Technical Bulletin

TB Number: 103
Date Issued: 10/26/2016
Expiration Date: Na

Subject/Key Words:	Conductivity Sensor/Housing PM Requirements and Parts ID			
Classification:	<input checked="" type="checkbox"/> Informational	<input checked="" type="checkbox"/> Mandatory	<input type="checkbox"/> Safety Alert	<input checked="" type="checkbox"/> Preventive Maintenance Impact
	<input type="checkbox"/> Warranty Impact	<input type="checkbox"/> Purchase Parts	<input type="checkbox"/> No Charge For Parts expires ___ / ___ / ___. Reference this TB# when ordering NC parts.	
Application/Product Line:	GAMA, Rearmount

Identifying MAN009154/55 Housings

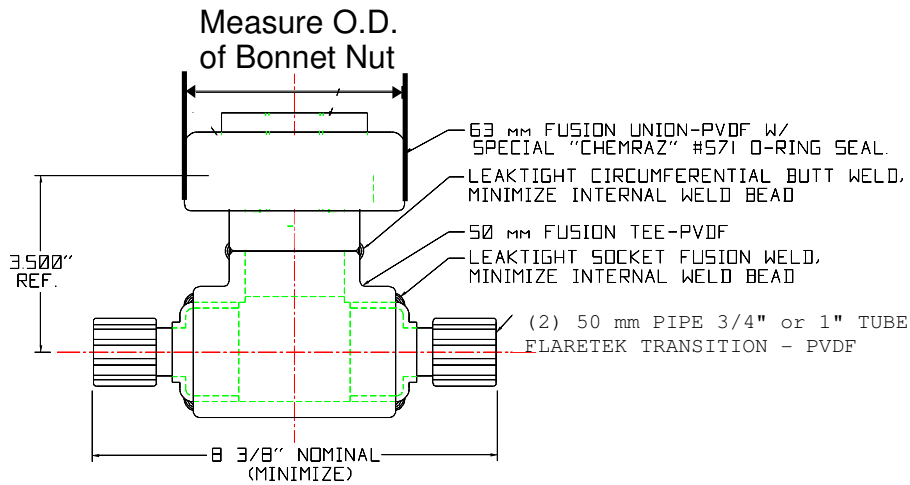
To determine if you have useable MAN009154 or MAN009155 housings, measure the outside diameter of the bonnet nut. It should measure 4.37".

Old, unusable MAN000870 and MAN000871 housings will measure 3.58". These housing are too narrow to accept the new sensors. They must be replaced.

O.D. MAN009154/55 = 4.37" CAN BE REUSED

O.D. MAN000870/71 = 3.58" MUST BE REPLACED
